## Addendum #4

Project: IN130-Inlow Hall-Replace Roof Phase 2-20240666

Project Number: 20240666

Date: February 12, 2026

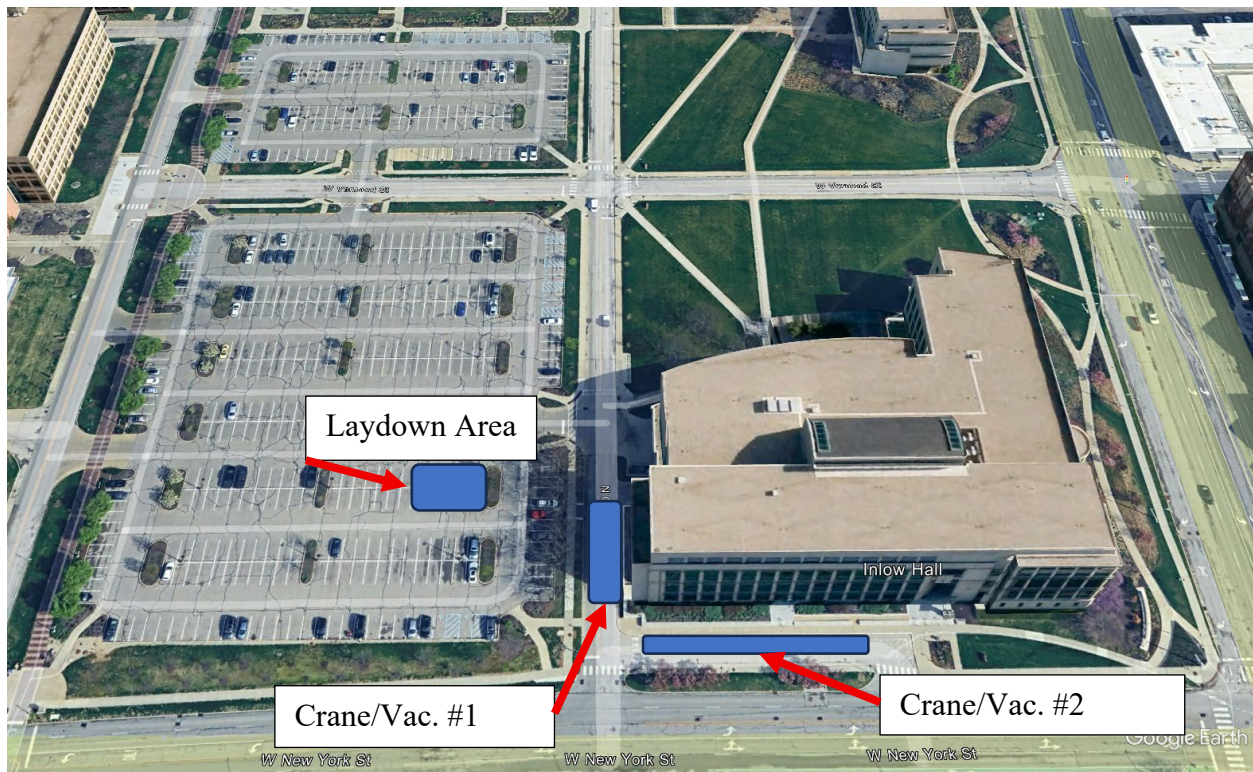
See the attached aerial overview for the designated area for material storage, dumpster and fence.

See the attached aerial overview for the crane and vacuum location. California street to be closed for the construction project. Inlow Hall parking garage entrance and loading dock will remain open.

The fire lane south of the building may be used for crane/vacuum access. The south lane must remain open at all times. This area is for temporary access only (not long-term), and vehicles must be removed by the end of the workday or on short notice.

**Laydown Area:**

See the shaded area above; 12 parking stalls are designated for material storage, etc.

**Crane/Vac. Area #1:**

See location above. The shaded area on California Street is the designated crane/vacuum truck location. The shaded area on California Street will be closed during construction. Access to the loading dock and Inlow Hall Parking garage entrance will remain in operation during the construction project.

**Crane/Vac. Area #2:**

See location above. The fire lane south of the building may be used for crane/vacuum access. The south lane must remain open at all times. This area is for temporary access only (not long-term), and vehicles must be removed by the end of the workday or on short notice.

2 ABOVE DECK ATTACHMENTS

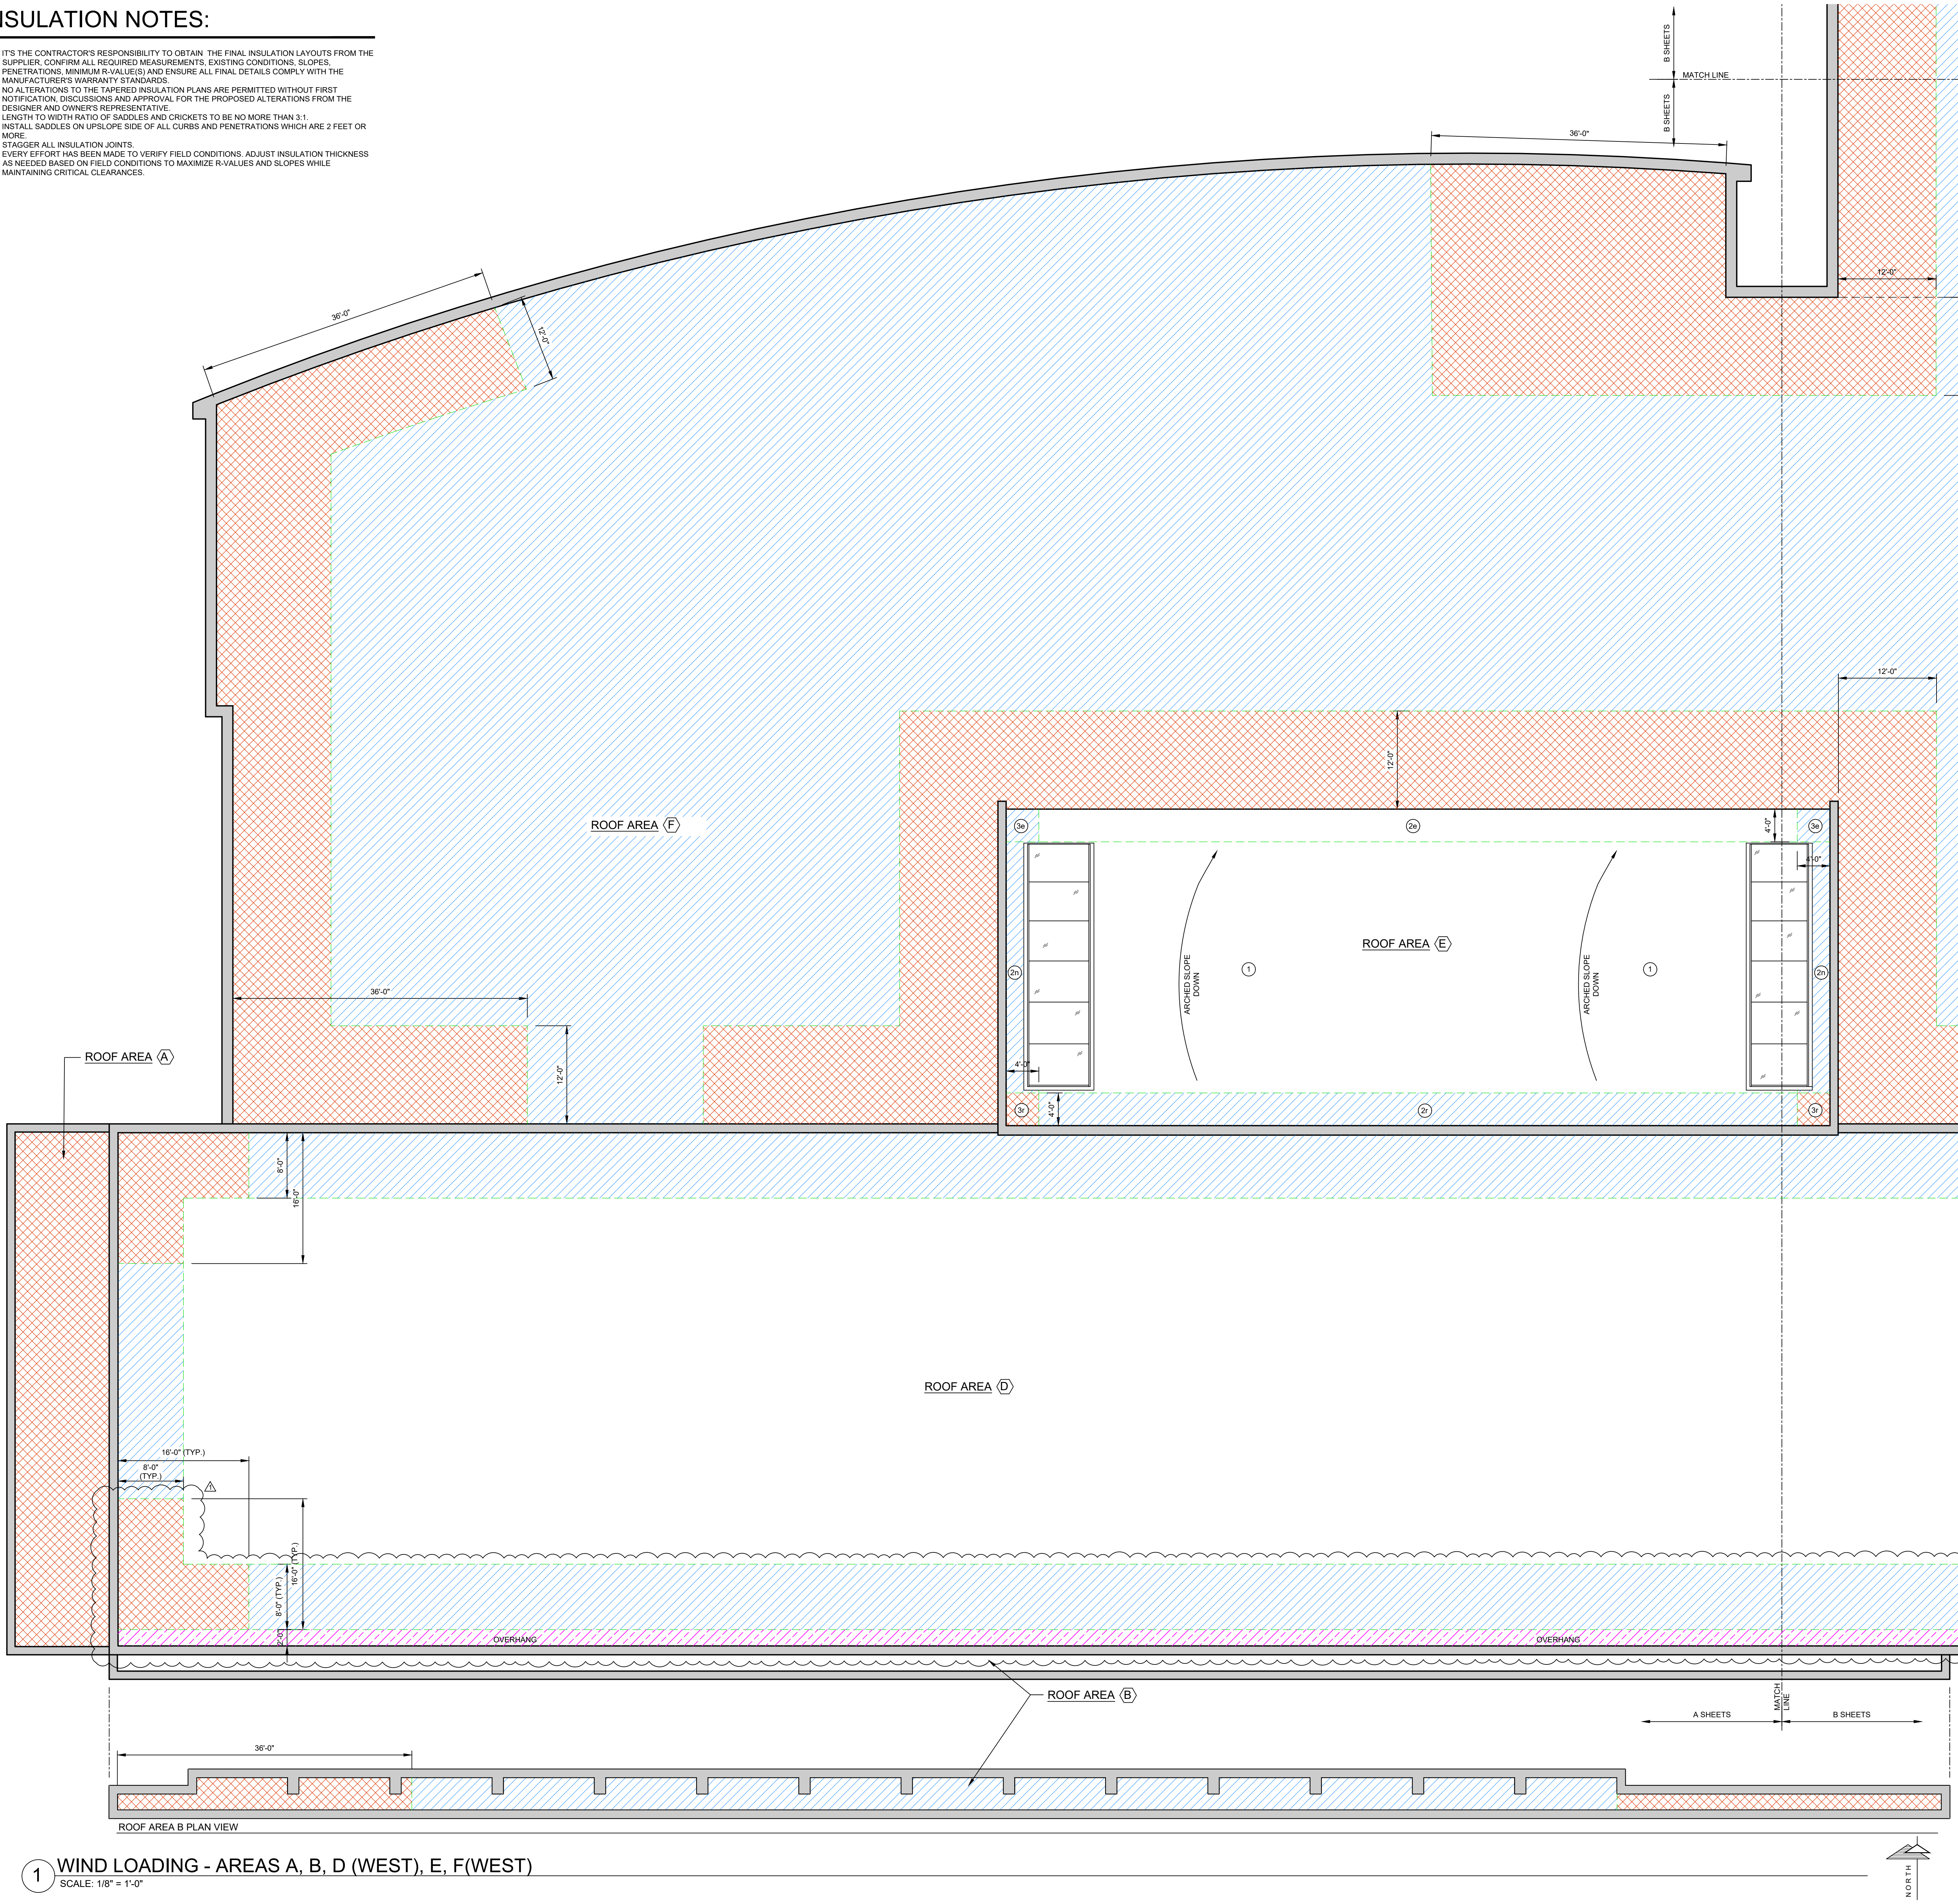
Insulation attachment has been revised. See the attached plan pages A1.3A and A1.3B and specification section 072224.

ABOVE DECK COMPONENT ATTACHMENT: AREAS A, B AND J

ATTACHMENT FOR CONCRETE DECKS	FIELD OF ROOF	PERIMETERS	CORNERS
COVER BOARD	MECH. ATTACH WITH 24 FASTENERS PER 4' X 8' BOARD (ONE FASTENER PER 1.33 SF)	MECH. ATTACH WITH 24 FASTENERS PER 4' X 8' BOARD (ONE FASTENER PER 1.33 SF)	MECH. ATTACH WITH 24 FASTENERS PER 4' X 8' BOARD (ONE FASTENER PER 1.33 SF)
INSULATION	LOOSE-LAID	LOOSE-LAID	LOOSE-LAID

ABOVE DECK COMPONENT ATTACHMENT: OVERHANGS AREA C

ATTACHMENT FOR CONCRETE DECKS	OVERHANG
COVER BOARD	MECH. ATTACH WITH 32 FASTENERS PER 4' X 8' BOARD (ONE FASTENER PER 1.00 SF)
INSULATION	LOOSE-LAID

ABOVE DECK COMPONENT ATTACHMENT: AREA E

ATTACHMENT FOR STEEL DECKS	ZONES 1 AND 2a	ZONES 2b, 2c AND 3a	ZONE 3b
COVER BOARD	MECH. ATTACH WITH 24 FASTENERS PER 4' X 8' BOARD (ONE FASTENER PER 1.33 SF)	MECH. ATTACH WITH 24 FASTENERS PER 4' X 8' BOARD (ONE FASTENER PER 1.33 SF)	MECH. ATTACH WITH 32 FASTENERS PER 4' X 8' BOARD (ONE FASTENER PER 1.00 SF)

ABOVE DECK COMPONENT ATTACHMENT: AREAS D, F AND H

ATTACHMENT FOR STEEL DECKS	FIELD OF ROOF	PERIMETERS	CORNERS AND OVERHANGS IN ROOF AREA D
COVER BOARD	MECH. ATTACH WITH 12 FASTENERS PER 4' X 8' BOARD (ONE FASTENER PER 2.67 SF)	MECH. ATTACH WITH 24 FASTENERS PER 4' X 8' BOARD (ONE FASTENER PER 1.33 SF)	MECH. ATTACH WITH 32 FASTENERS PER 4' X 8' BOARD (ONE FASTENER PER 1.00 SF)
TOP INSULATION LAYER	LOOSE-LAID	LOOSE-LAID	LOOSE-LAID

ABOVE DECK COMPONENT ATTACHMENT: AREAS G

ATTACHMENT FOR STEEL DECKS	FIELD OF ROOF	PERIMETERS	CORNERS
COVER BOARD	MECH. ATTACH WITH 12 FASTENERS PER 4' X 8' BOARD (ONE FASTENER PER 2.67 SF)	MECH. ATTACH WITH 24 FASTENERS PER 4' X 8' BOARD (ONE FASTENER PER 1.33 SF)	MECH. ATTACH WITH 32 FASTENERS PER 4' X 8' BOARD (ONE FASTENER PER 1.00 SF)

- NOTES:  
1) IF ANY PORTION OF THE BOARD LIES IN PERIMETER OR CORNER ZONE, ENHANCE THE FASTENING OF THE ENTIRE BOARD  
2) VERIFY WITH THE MANUFACTURER ALL ATTACHMENT REQUIREMENTS INCLUDING BUT NOT ARE LIMITED TO FASTENER TYPE, DIAMETER, LENGTH, MATERIALS, SPACINGS, ENGAGEMENT AND EMBEDMENT.
